Our reference: MGLA061124-4365

I'd like to make an FOI (actually probably an EIR) request for information relating to planning application Ref. 22/00300/FUL, which pertains to 100 Woodgate Drive, London SW16.

## **Planning application Ref. 22/00300/FUL (Woodgate Drive)**

**RE PLANNING APP: 100 WOODGATE DRIVE, STREATHAM GLA/2022/0224 (LBL ref: 22/00300/FUL)**

### **The long range view of the building**

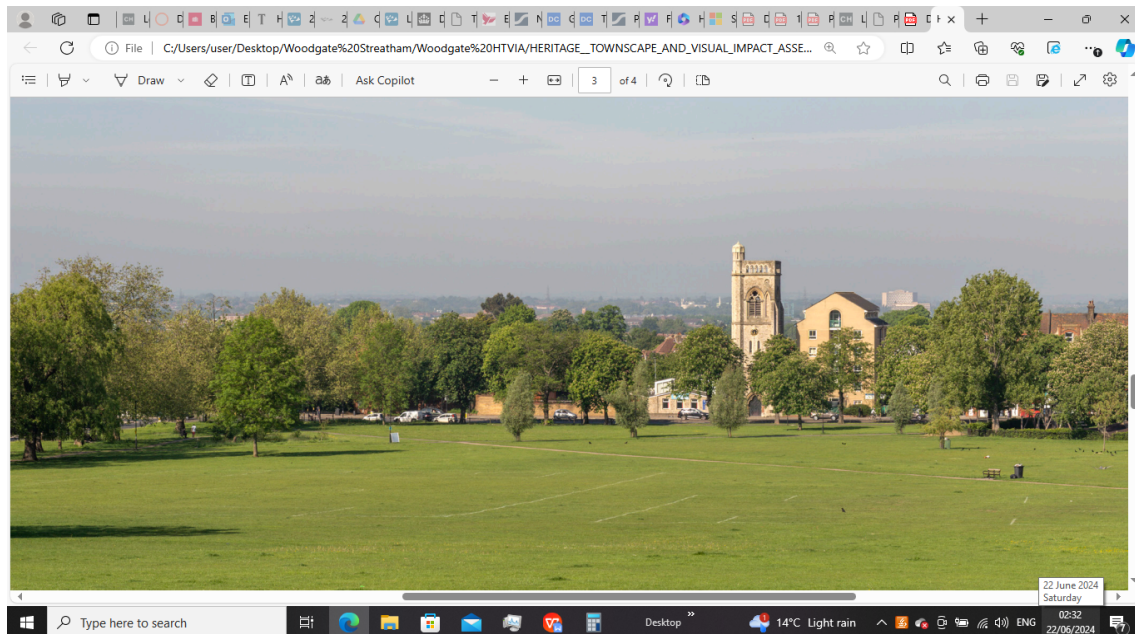
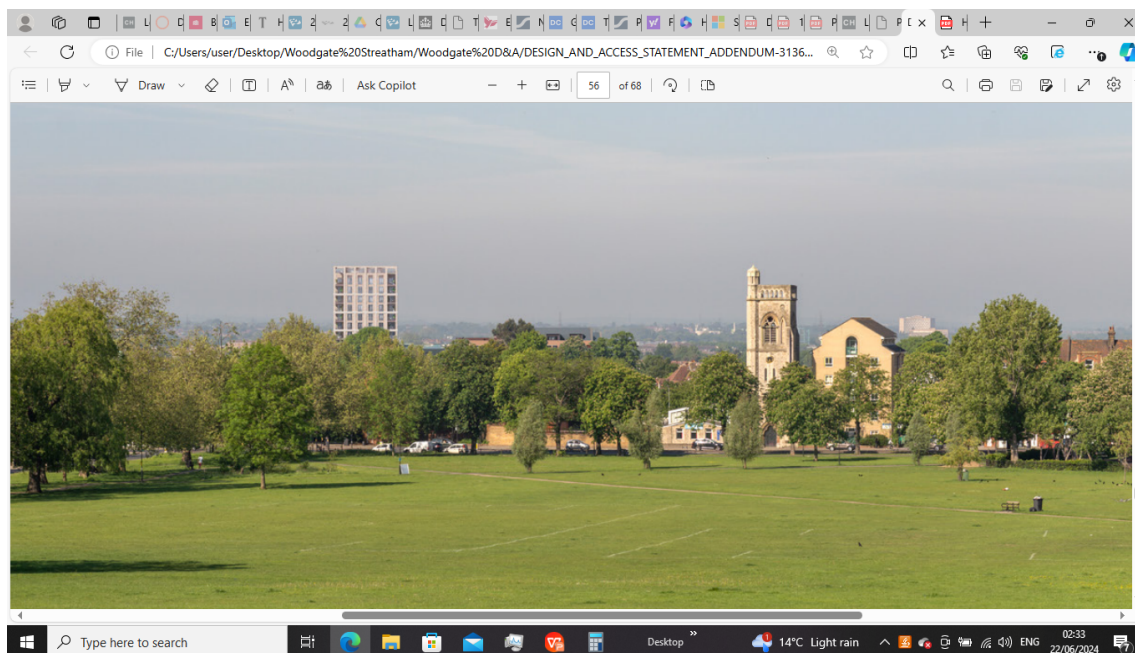
The most negative impact is that on the protected view from the high slopes of Streatham Common, a designated Local Panorama. This is one of only two protected Panoramas in all of Streatham, afforded by the higher parts of the Common. The objective of providing protection for the Panoramas identified in the Local Plan "is to ensure that no foreground or middle- ground development is intrusive, unsightly or prominent in relation to the panoramic view as a whole, or landmark buildings within".<sup>3</sup>

The application would result in the upper six storeys of Block C and the upper storeys of Block A of the proposed development would be entirely visible in this protected Panorama, fatter and taller than the listed church tower and competing with it for the visual focus; yet clearly considerably further away - it is in fact double the distance of the church from the viewer, making its appearance oddly out of scale with the listed church tower and mature trees, and thereby confusing the viewer: is it in the middle distance or further away?

The applicant's HTVIA claims that this impact is not incongruous since  
*"the proposed development will appear consistent with the dense urban environment emerging in London and which already makes up the setting of the Common and locally listed buildings, albeit outside of this view".*

This is wrong on two fronts: firstly, the surrounding area largely hidden in this view is not a “dense urban environment” but a low-rise relatively low-density sprawling suburbia; and secondly, it is precisely the fact that the urban realm beyond the Common is largely invisible and barely hinted at beyond the listed Church which makes this an unusually appealing vista, and is why it receives specific attention in the Local Plan policy on protected views.

## Quality of design: communal garden/amenity space/ children's playspace

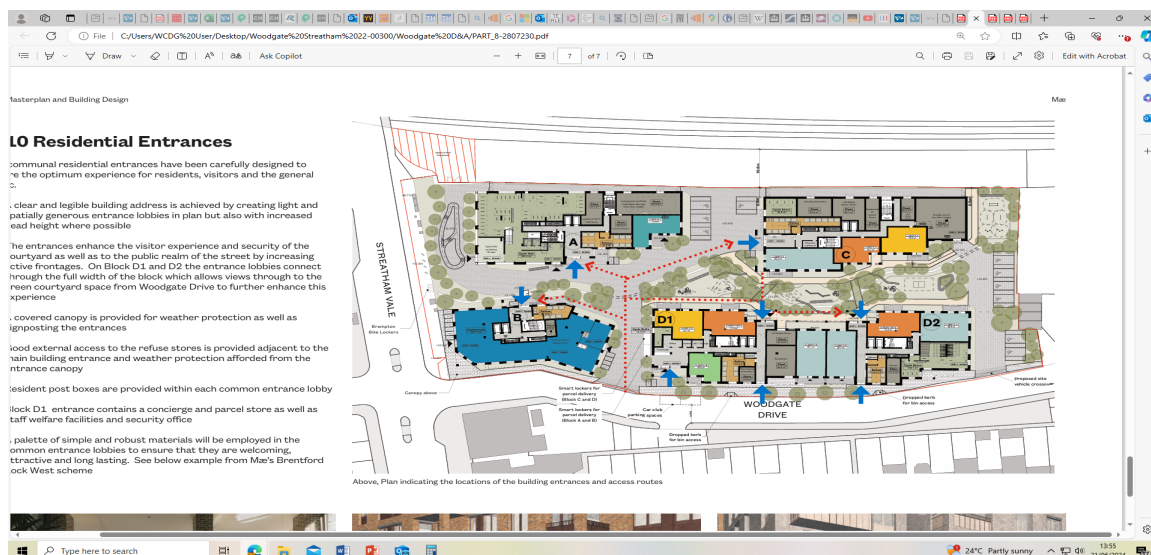
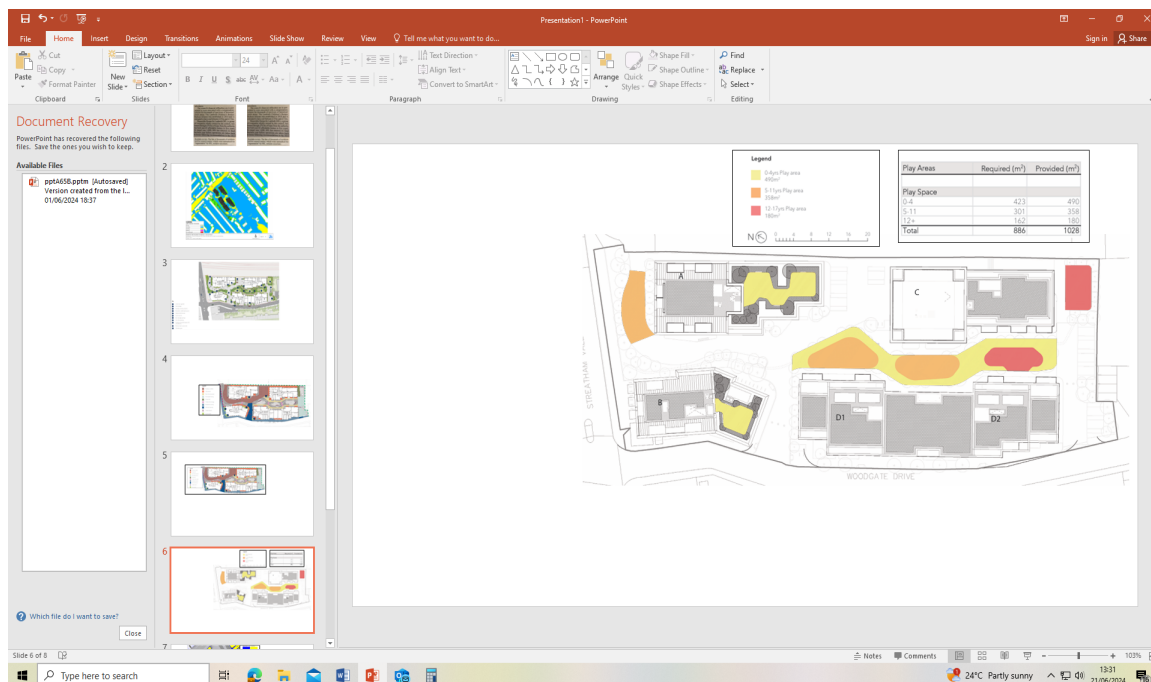
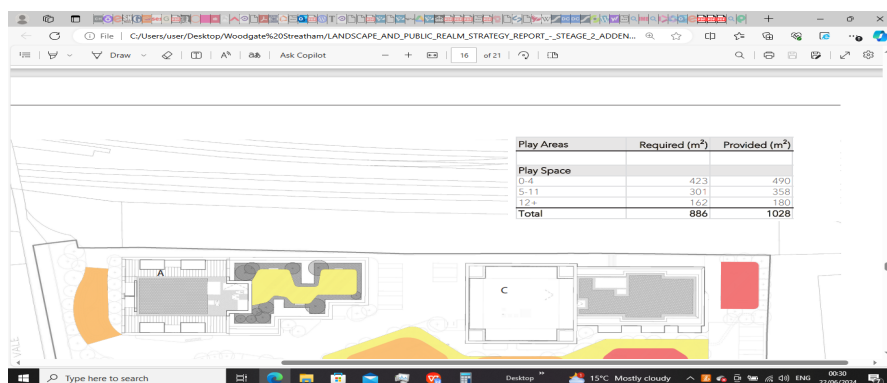
There are a series of small spaces between the tall buildings, which function as the main thoroughfare for the hundreds of residents entering and leaving the buildings. The applicant claims that these will also function as communal gardens providing greening, flowers, and seating as well as children's playspaces for various ages and fitness areas.

Questions were raised about these spaces by the Design Review Panel:

*"The Panel thought that the absence of other play space within a 400m radius of the site could mean the proposed play space is heavily used by the surrounding community and not just future residents. As such, there should be careful consideration on the type of play proposed and what it offers to the community and residents. The applicant should also consider how play space works and interacts with the proposed commercial units. More generally, the Panel were concerned about the location and quality of play space which would be in full shade. Play space within the residential courtyard and how it integrates in the landscaping should be carefully considered by the applicant."*<sup>8</sup>

The 237 homes are expected to accommodate around 77 children of all ages, generating a need for at least 886m2 of playspace in total. The applicant claims that 1,028m2 of children's playspace is provided, but this includes the roof.

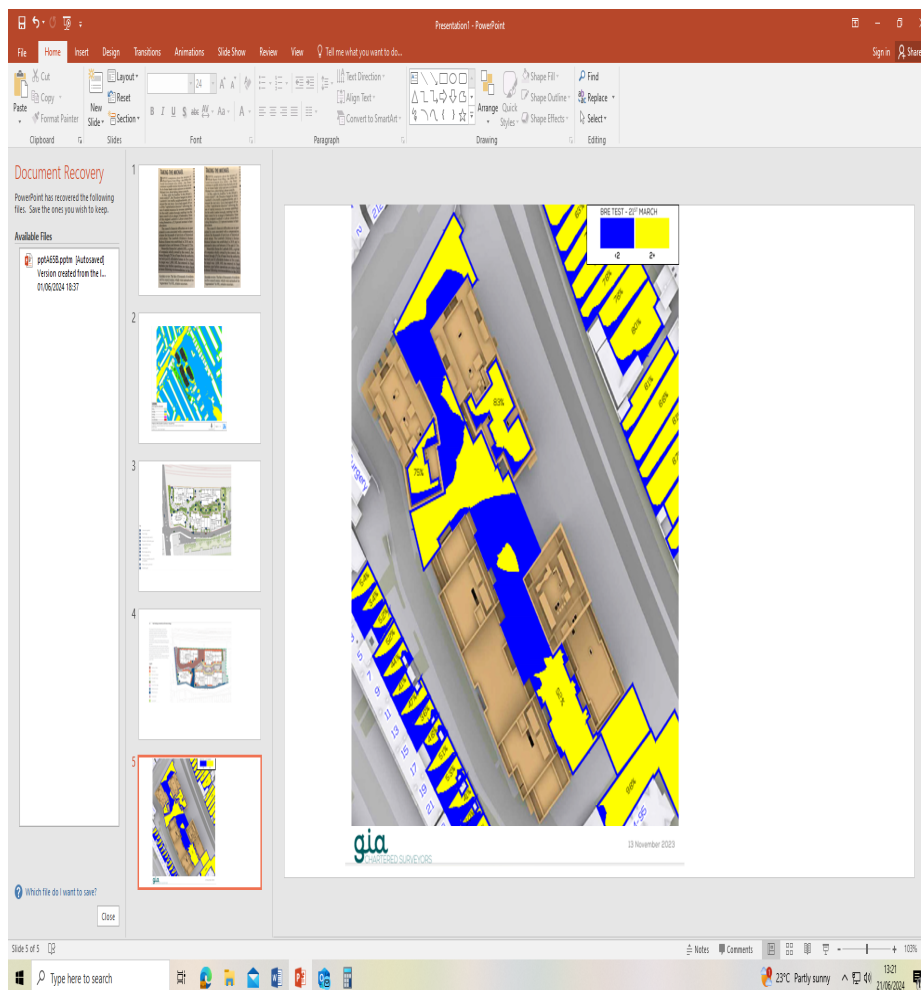
According to the revised GIA Daylight, Sunlight & Overshadowing report<sup>9</sup> nearly half (48%) of the development's main amenity space between the buildings will receive less than 2 hours of sunlight at the equinox. Contrary to guidance the report fails to analyse

the impact in winter, but clearly the communal garden will receive even less or no sunlight at all during the winter. This clearly fails the aspirations of the Housing Design Guidance B9.5:

“Maximise the quality and availability of daylight and sunlight in communal outside spaces, *particularly in winter*. It is particularly important that spaces designed for frequent use (including sitting and play spaces) *receive direct sunlight through the day*, particularly at times they are most likely to be used.”

But this problem of overshadowing has only worsened as the design has evolved upwards, with the earlier Design & Access of Dec 2021 showing only 33% of the amenity space having less than 2 hours sunlight<sup>11</sup> but this has now ended up as 48% of the communal garden being in almost permanent shadow.

## Environmental Impact: Microclimate

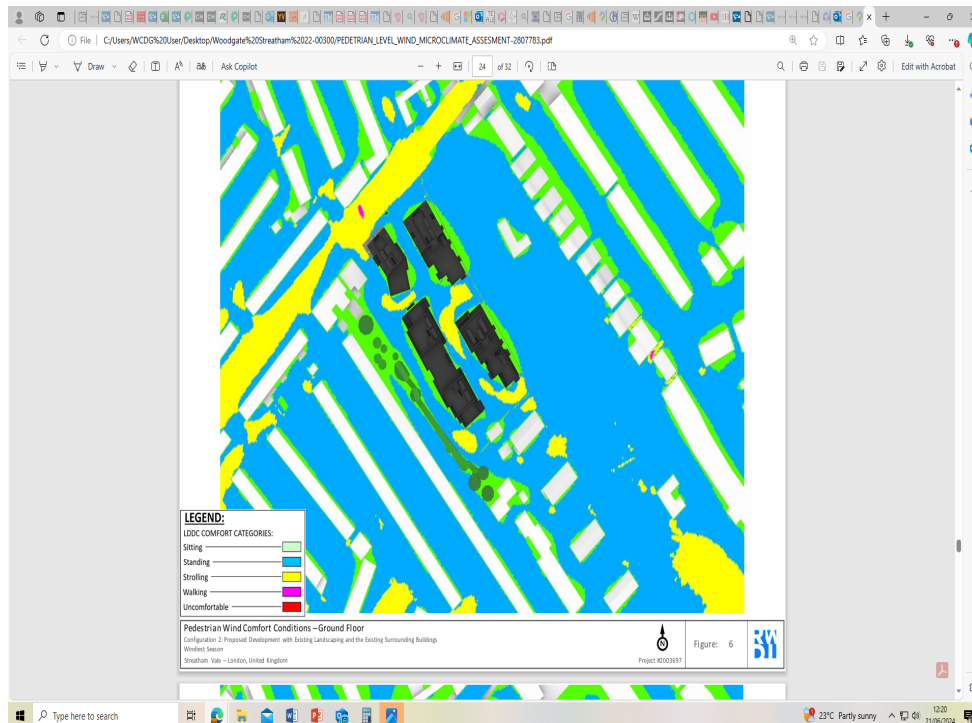
The Design and Access Statement states that the communal amenity space “provides for a range of residents needs including children’s play and amenity space for all ages.

Green soft landscaped areas are maximised ... and add visual delight for residents and the public.”<sup>12</sup>

The Microclimate report evidences that major parts of the communal garden community space will not be able to fulfil this function because it will not have the microclimate to sit or stand, but would only be tolerable walking, thus rendering the provision and siting of benches obsolete, for example. The microclimate some distance beyond the development is also significantly impacted.

### Design: dual aspect

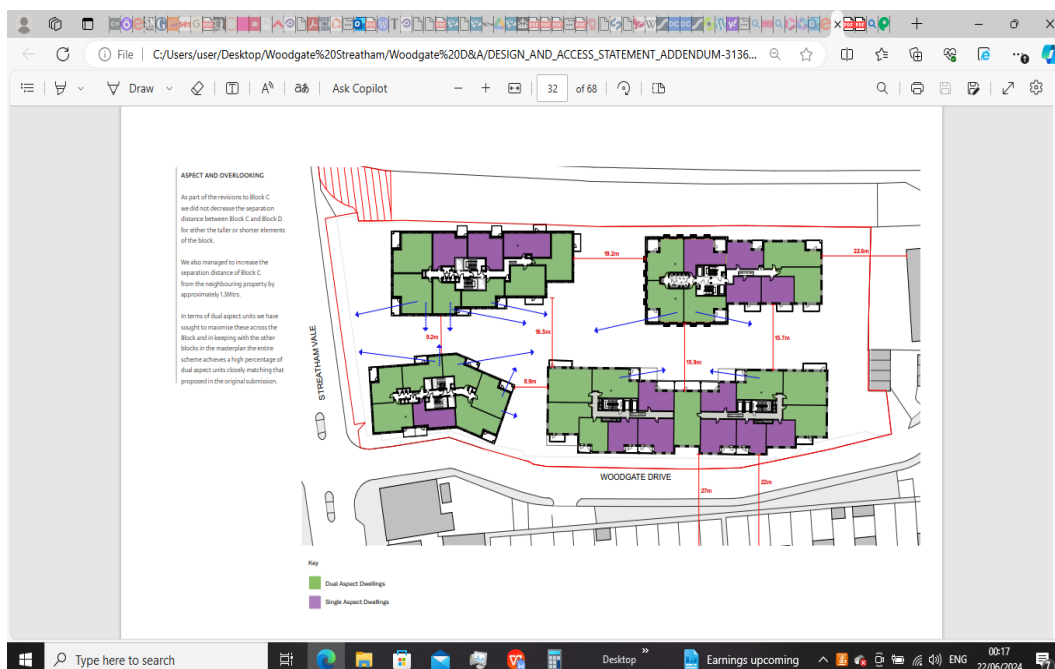
LLP Policy H5 explains that new residential development will be expected to provide dual-aspect accommodation, unless exceptional circumstances are demonstrated.

108 flats (46%) would be single aspect. 32 of these would be low cost rent, and 18 intermediate. A large number of these would have their single aspect looking directly over the railway line, with its associated noise and pollution - 5 flats on each floor of blocks and A and C.

What are the exceptional circumstances which policy requires in justification? Guidance gives an example “where one side of a dwelling would be subjected to excessive noise or outside air pollution”. One side of the site looks directly over the railway line, with its excessive noise and pollution - but this is also the side with a large number of single aspect flats overlooking that very railway line! 5 flats on each floor of the two blocks A and C. This is exceptionally inappropriate for single aspect homes.

In fact the applicant provides no explanation anywhere in the DAS or Planning Statement of the exceptional circumstances preventing the provision of dual aspect residences. The need to maximise the number of dual aspect flats was raised by the local authority at pre-app<sup>13</sup> and by the GLA at Stage 1, (when the single aspect was much lower at 26% of flats) which stated
